**ENVIRONMENTAL IMPACT REPORT
ADDENDUM**

HEADLANDS DEVELOPMENT AND CONSERVATION PLAN

DANA POINT, CALIFORNIA

September 2004

FIGURE 4.16.1

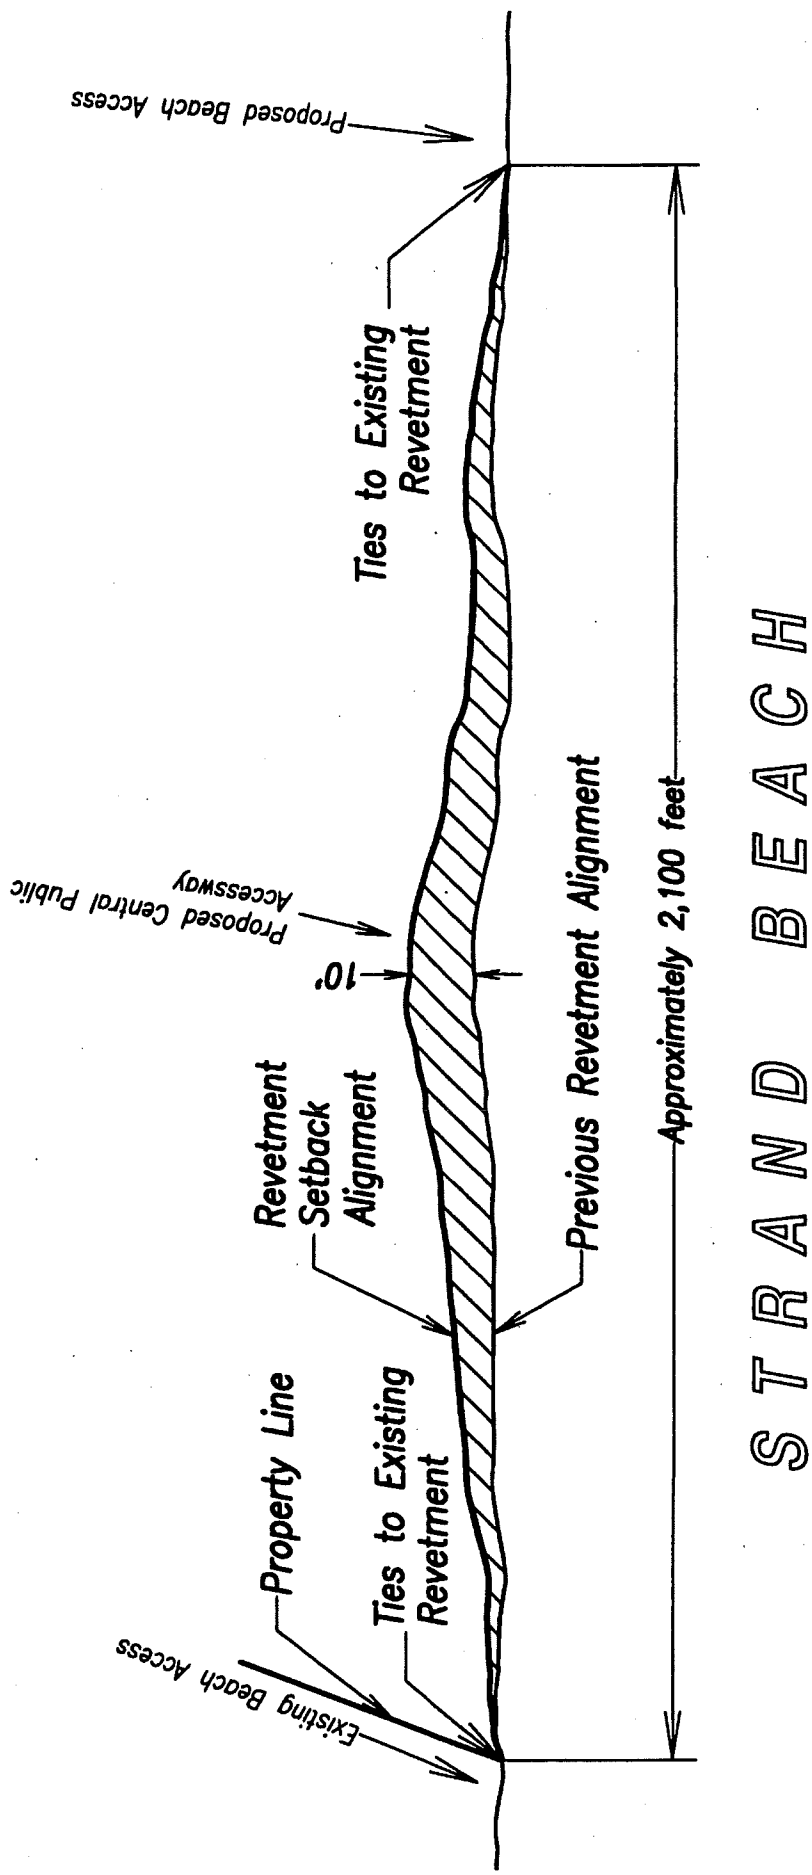
The LCP Amendment modifications approved by the Coastal Commission include the landward realignment of the existing revetment 10 feet at the center, transitioning back uniformly for approximately 1,050 feet in both directions to tie to the existing revetment alignment at either end. (See Figure 4.16.1.) Overall, the revetment alignment will average five feet farther landward (or easterly) than the existing alignment. The net result of the landward revetment realignment will be an increase in beach area of approximately 10,500 sq ft, thus improving public recreation and public access. In addition, the approved modifications require an eight-foot-wide public walkway with seating areas along the top of the revetment. The walkway will facilitate year-round lateral public beach access regardless of the tide or seasonal sand level. The Coastal Commission determined that such improvements, when implemented, would be consistent with the requirements of Section 30610(d) of the Coastal Act as repair and maintenance.
